BRIDGE #5A - OUTBOUND

PALI HWY Proj. No. BF-061-(8)

(CONTRACT CHANGE ORDER NO. 3)
BRIDGE 5A, ABUT. #2 AND WING WALL #2
JULY 12, 1960

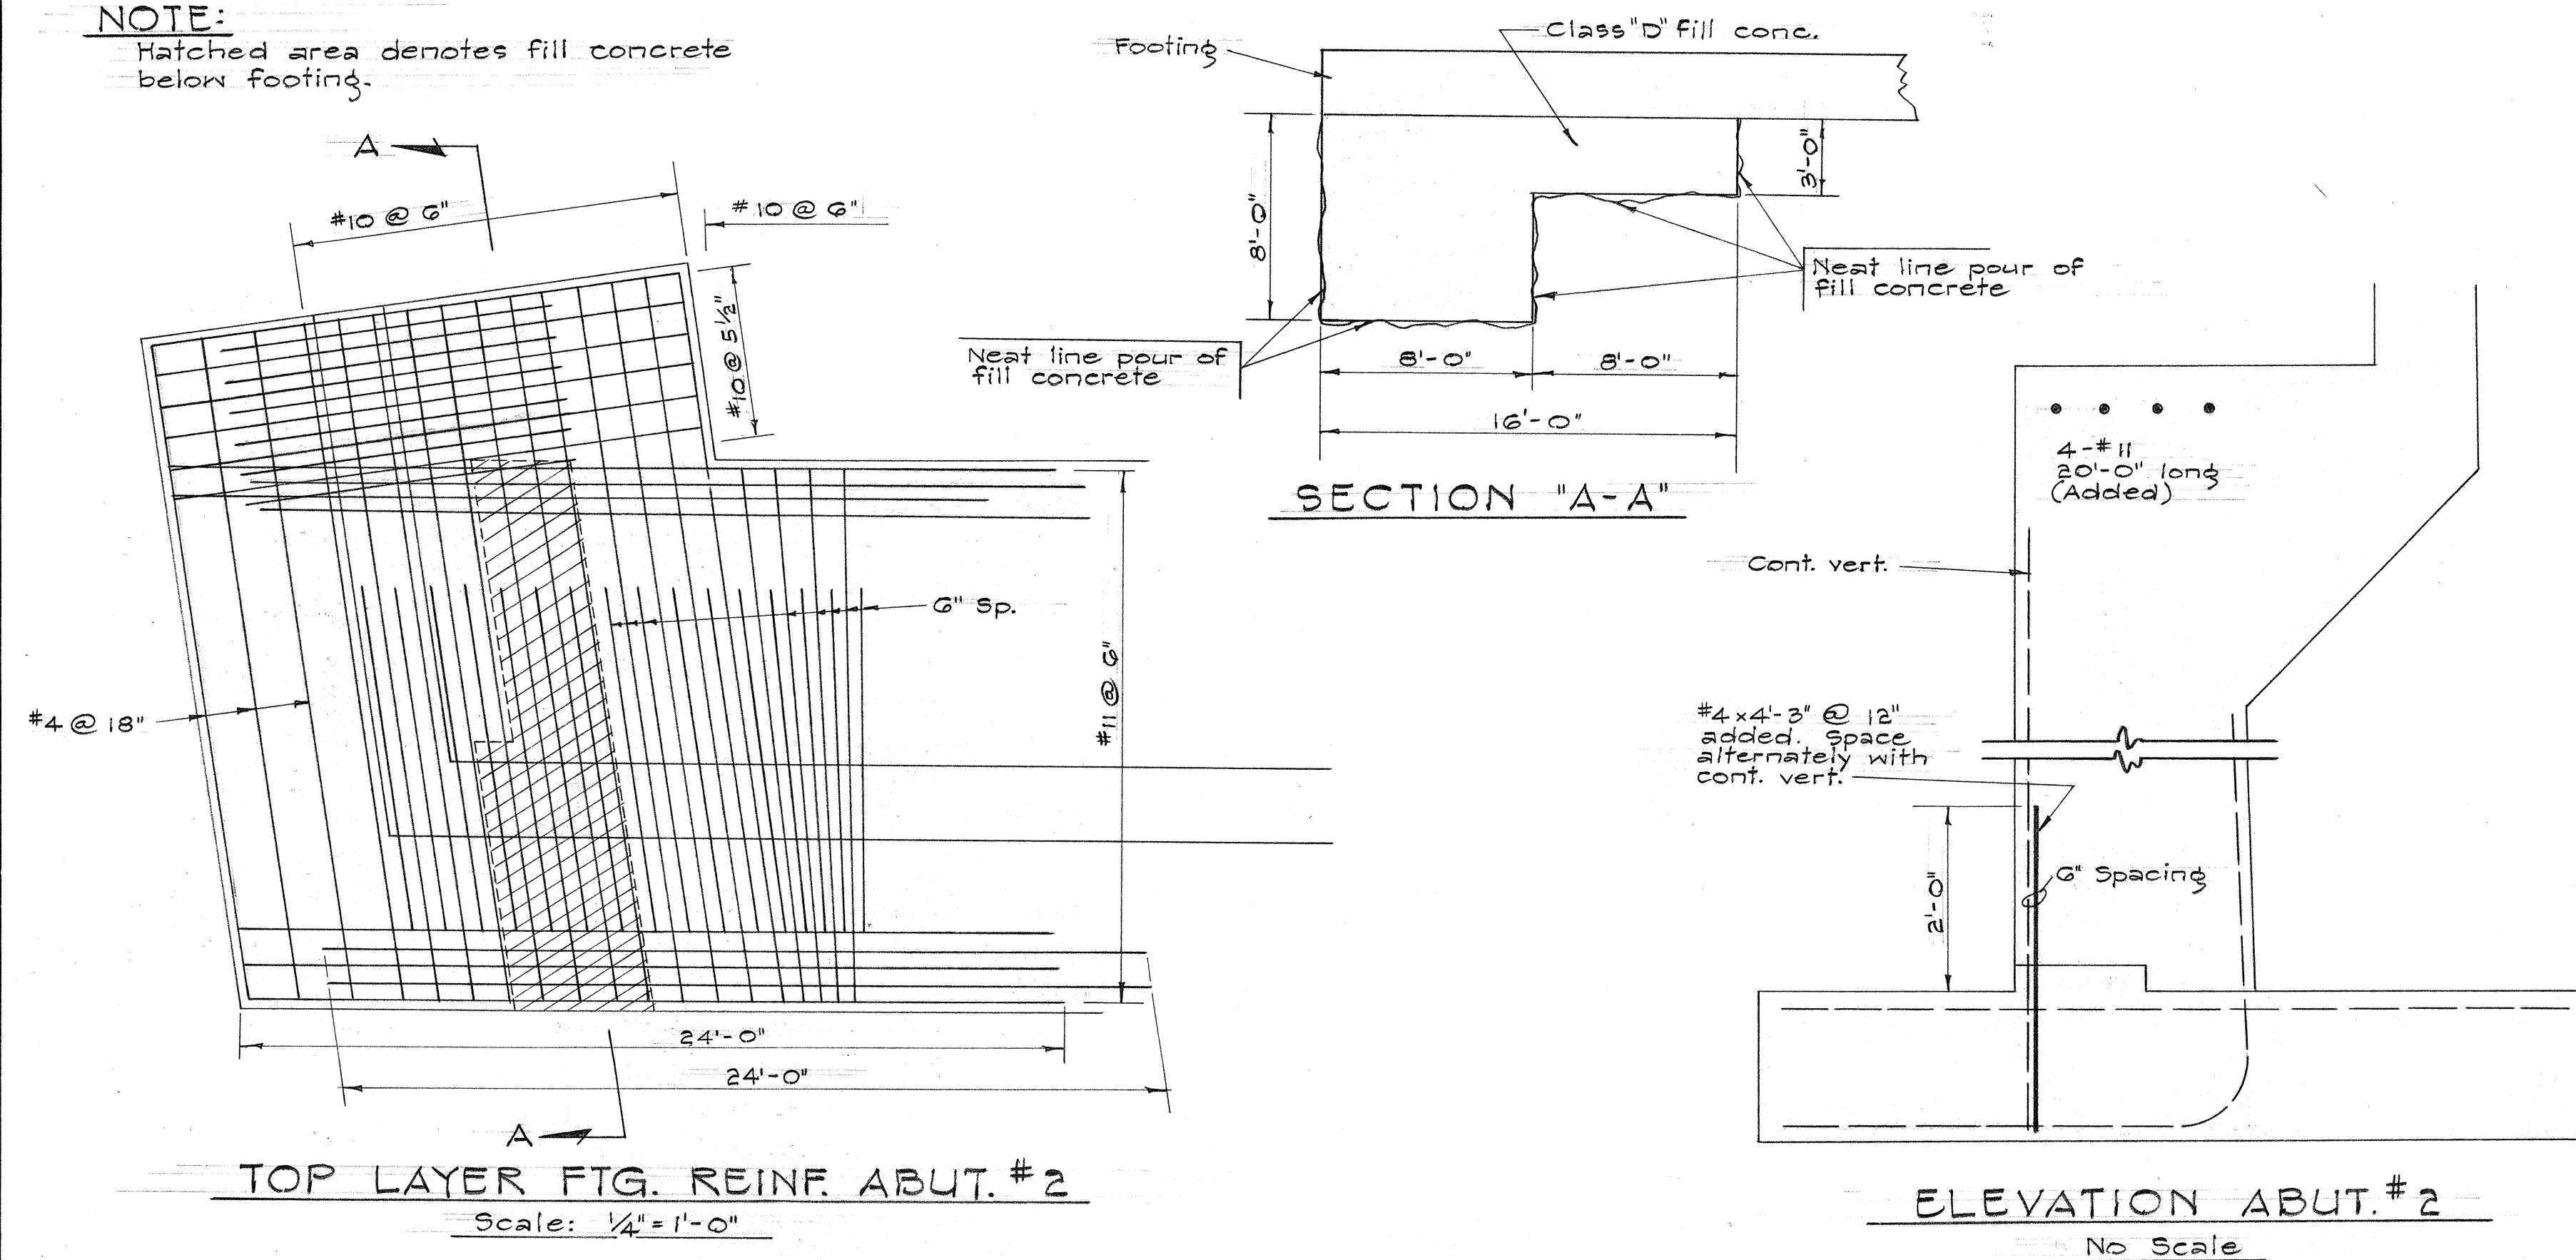
NOTE:
Hatched area denotes fill concrete below footing.
